Access Compliance Report

Public Rights-of-Way (Curb Ramps)

Intersection ID: 2852	Main Street: EDINMEADOW_LN	Cross Street: HUNTMEADOW_DR	Location: NE
ADA ID: 8D74B1C6BE1F	Ramp Type: BlendTrans1	Initial Pass/Fail: Fail	Overall Compliance: No
		Severity Score: 1.25

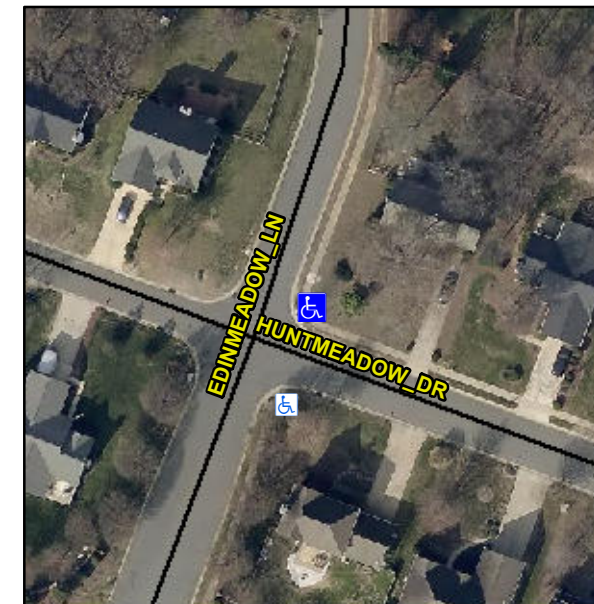
Not Found, R304.5.3

Remove & Replace Curb Ramp With Two New Directional Ramps or Equivalent.
